REVISION TRANSMITTAL

This sheet transmits Revision 1 to MTL-55-02 , which:

STABILIZERS - HORIZONTAL FASTENER REPLACEMENT

MTL-55-02
Page 1 of 6

Figure 1. Horizontal Fastener Location (Sheet 1)

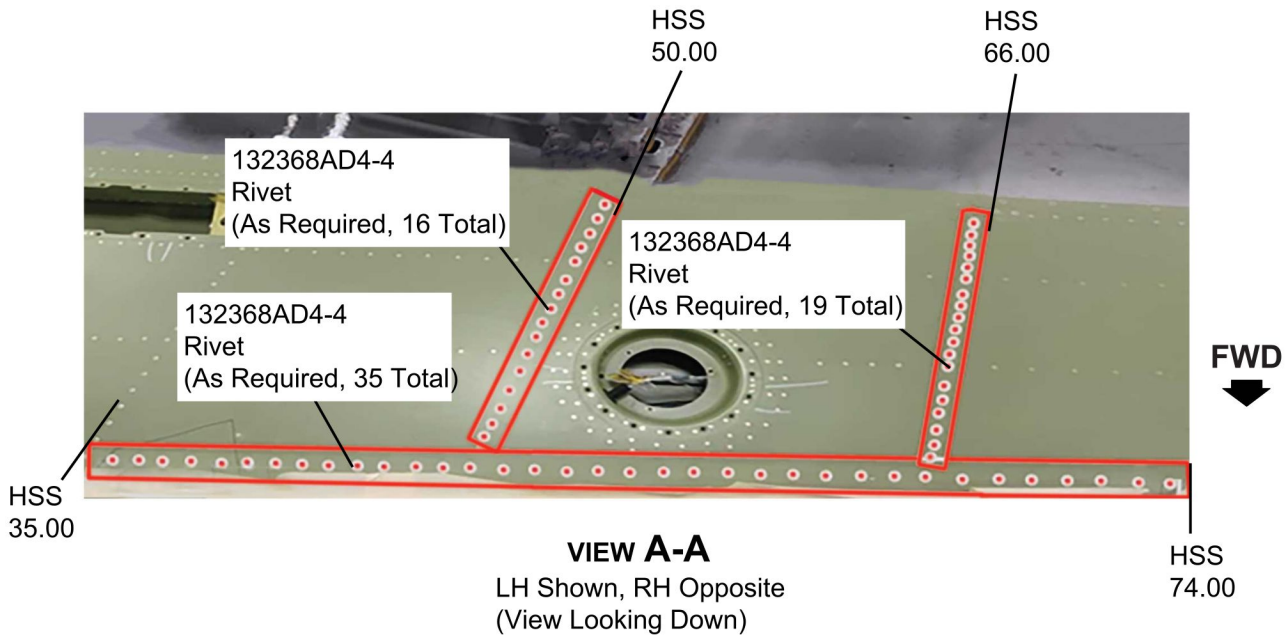
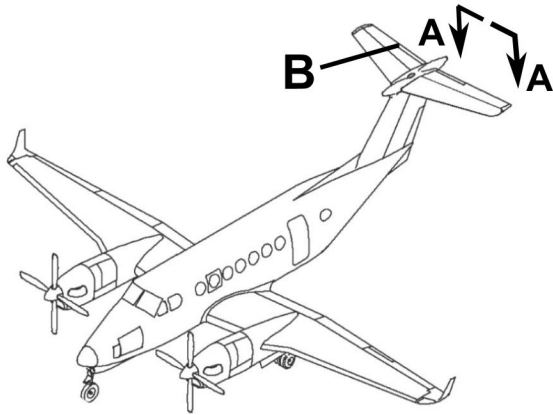
NOTE: The highlighted red areas of Figure 1, Sheet 1 located on the upper surfaces of the left and right horizontal stabilizers are the areas that need to be inspected with a magnet.

NOTE: Only the areas highlighted in red needs to be inspected for magnetic fasteners.

Figure 1. Horizontal Fastener Location (Sheet 2)

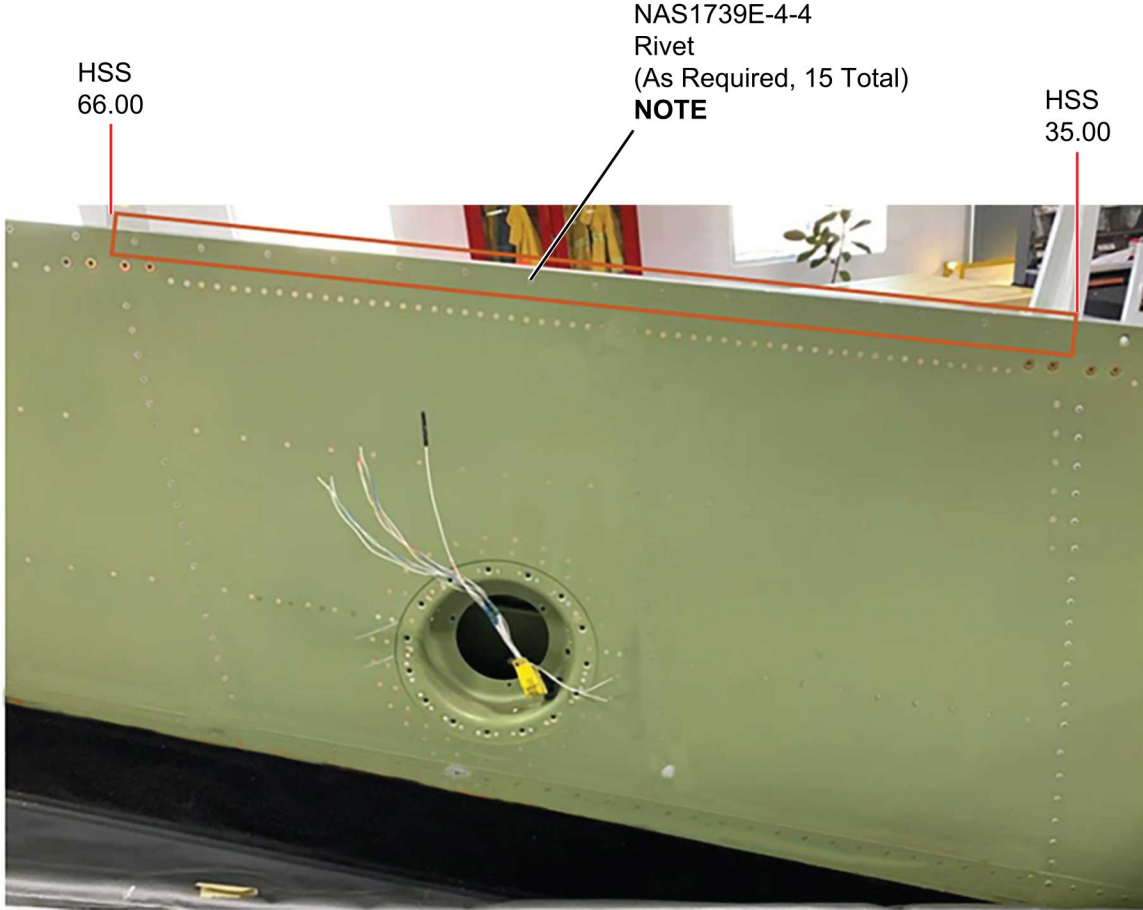
- A. Inserted Note under Step 3. A. (6).
- B. Revised Steps: 2. B., 3. B., and 3. B. (2).
- C. Revised Note on Figure 1, Sheet 2.

NOTE: Only the rivets that attach the 101-620010-9 Cove Closure needs to be inspected on the upper and lower surfaces.
